# CLIMATE CONTROL AIR CONDITIONER

## CC RV-C Gateway Service Bulletin

Model	Original Kit Numbers	Replacement Kit Numbers
Any AC Using Single Zone Climate Controls	3316945.020 3316945.040	3316945.021 3316945.041

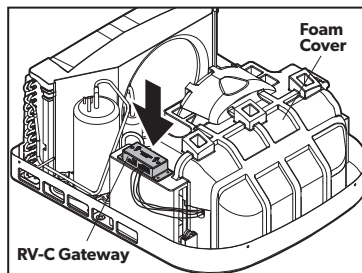
1. Locate the CC RV-C Gateway near the AC, through the Plenum, or remove the AC shroud.
2. Remove the two strips of foam mounting tape.
3. Unplug the harness from the CC RV-C Gateway and remove the CC RV-C Gateway.
4. Verify the replacement CC RV-C Gateway box shows the correct replacement part#’s (see page 1).
5. Attach the harness to the new CC RV-C Gateway.
6. Apply two strips of foam mounting tape to the replacement CC RV-C Gateway and position in the AC (see suggested mounting locations below).
